Addendum Number Two

To The Drawings and Specifications for
Hadley Middle School – Wichita, Kansas
Wichita Unified School District # 259

Issued: April 23, 2010

HANNEY & ASSOCIATES ARCHITECTS

FIRE ALARM SCHEDULE

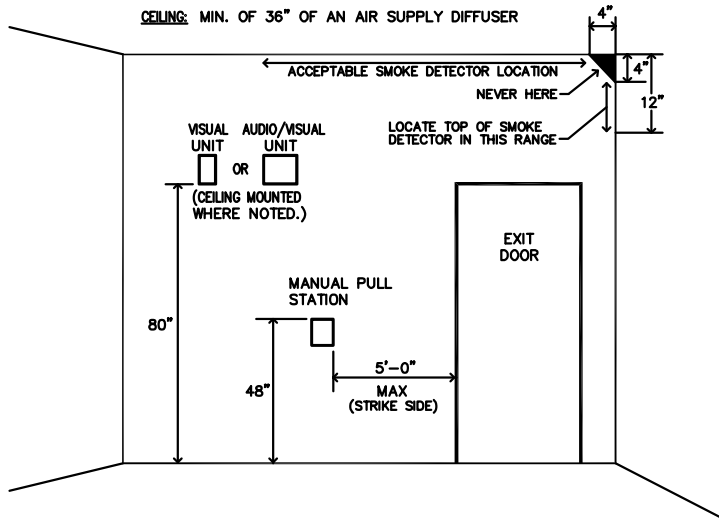
- 4.1 Relocate the existing intercom and master clock equipment from the existing admin area to new admin area, per owner's instructions. Extend conductors.
- 4.2 Gym/FEMA room. Delete 2 intercom horns.
- 4.3 Fire Alarm Schedule. See attachments. Interlock gym smoke beam detectors with double interlocked fire sprinkler system.
- 4.4 Node room location to terminate data and phone conductors. Directly across the corridor to the east, of the boiler room and just north of the faculty restrooms. Reference sheet "CODE 2"
- 4.5 Typical Data Rack detail on sheet E1.3. Surge protection strip shown for location reference only. Not required in this project.
- 4.6 Sheet E1.4
"DISTRIBUTION DIAGRAM" - panel XL2 shall be 80A in lieu of 60A as listed.
